November 17, 2023

**Re: Comprehensive Environmental Incorporated (CEI) Peer Review Comments
Jackson Square Notice of Intent
Broad and Commercial Streets**

This letter is in response to questions and comments in a review letter dated October 18, 2023, from Comprehensive Environmental Incorporated (CEI) for the above-referenced project.

FLOOD PROFILES
HERRING BROOK

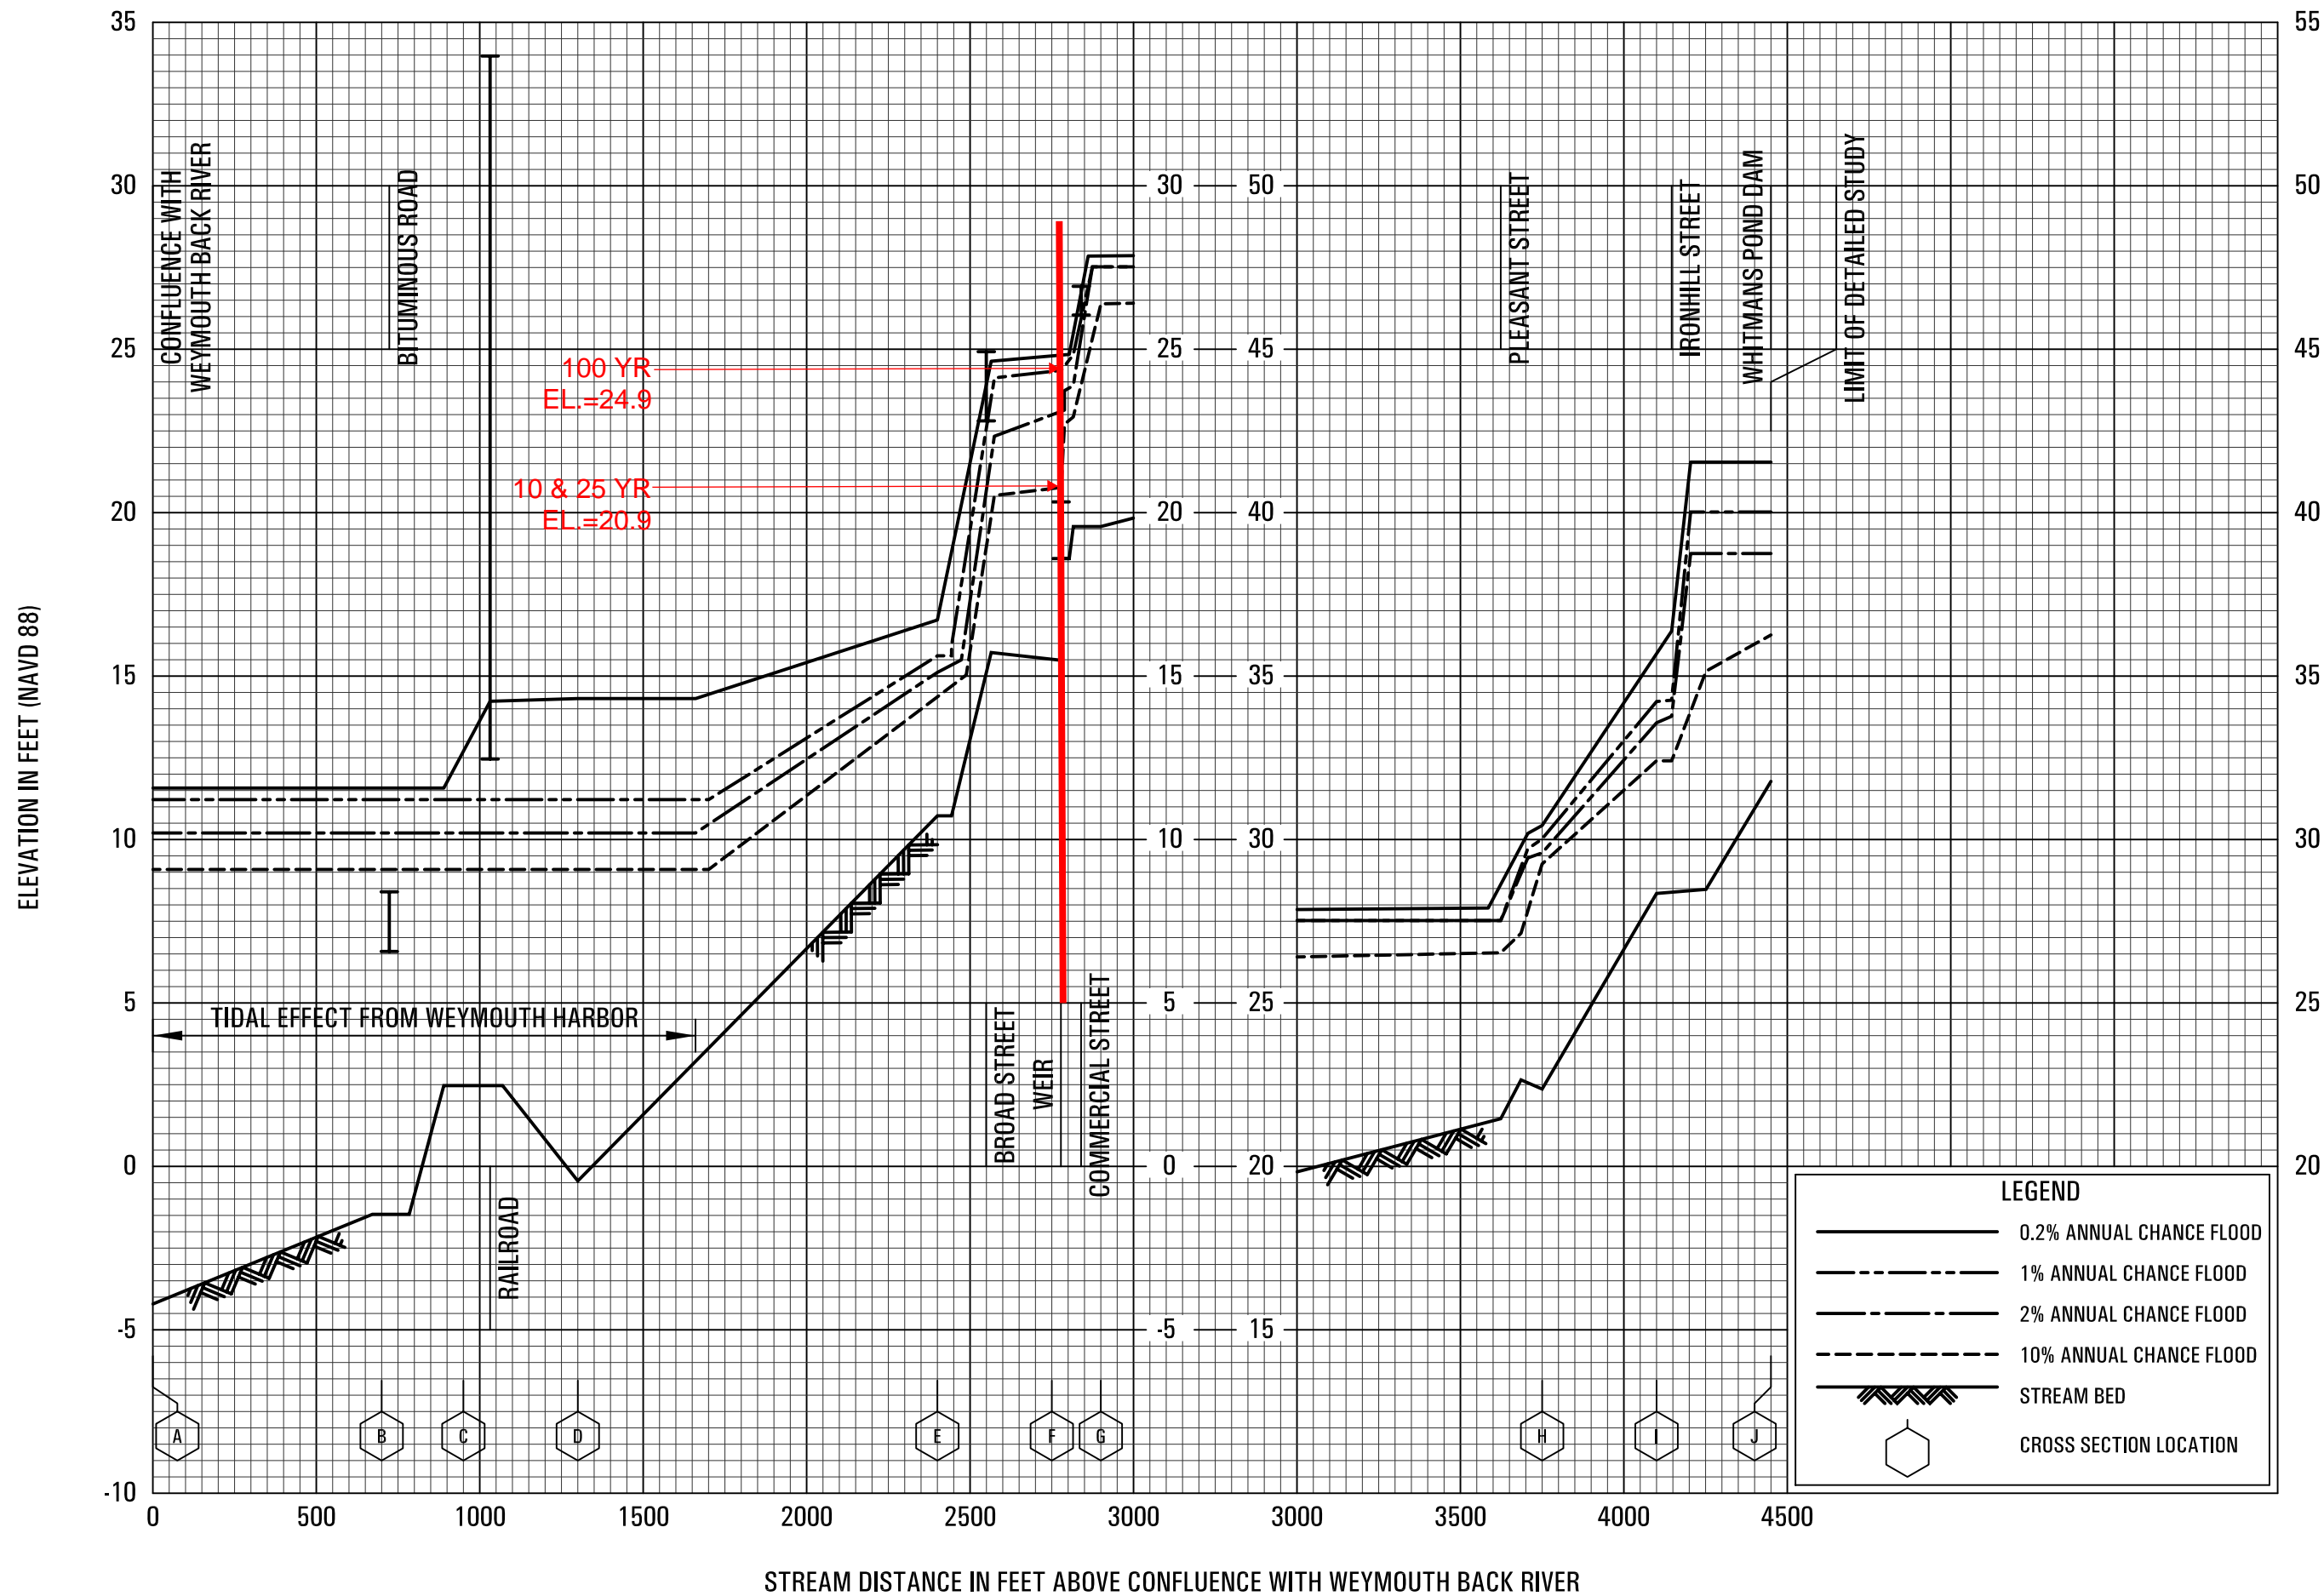
The applicant is proposing peak rate control for Site C with a rain garden that discharges to Herring Brook. However, the outlet of the rain garden does not account for tailwater conditions of Herring Brook in the HydroCAD model. It appears that no elevation has been set for the bottom of the Herring Brook in the model and that the flows within Herring Brook are too small compared to the FEMA studies. This could affect the WSE within the rain garden and release rates so should be reanalyzed.

The Town of Weymouth has filed a Letter of Map Revision (LOMR) with FEMA for the project area. Based upon review of this information and the FEMA Flood Profiles for Herring Brook (refer to attached), the water surface elevations (WSE) at the weir are as follows:

Flood Profiles	WSE Elevations (NAVD 88)		
	2-Yr. Storm.	10 & 25 Yr. Storm	100 yr. Storm
	Current FEMA Flood Profiles		
Herring Brook Weir	14.32 (MEG survey Jan. 2023)	20.9	24.9
	WSE Elevations LOMR (NAVD-4.9)		
		16.00	20.00
	WSE Elevations Weymouth Base (NAVD+6.63)		
	20.95 (MEG survey Jan. 2023)	22.63	26.63

The HydroCAD analysis for the rain garden has been revised to account for the

tailwater (WSE) conditions of Herring Brook using LOMAR elevations adjusted to Weymouth Base. Please refer to the Post-Development HydroCAD analysis in Appendix B of the Drainage Calculations and Stormwater Management Plan.

**Drainage Areas for Proposed BMPs
 Herring Brook Watershed
 Weymouth, MA**

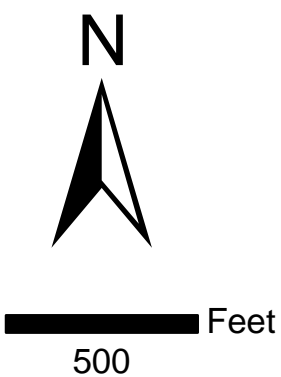
2. Please include the delineated basin used to size the Stormceptor STC-16000.

The delineated basin (1864A-1) is attached to this letter. The Horsley Witten Group developed this delineation in the Stormwater Improvement Project – Herring Brook Report, dated February 2011.
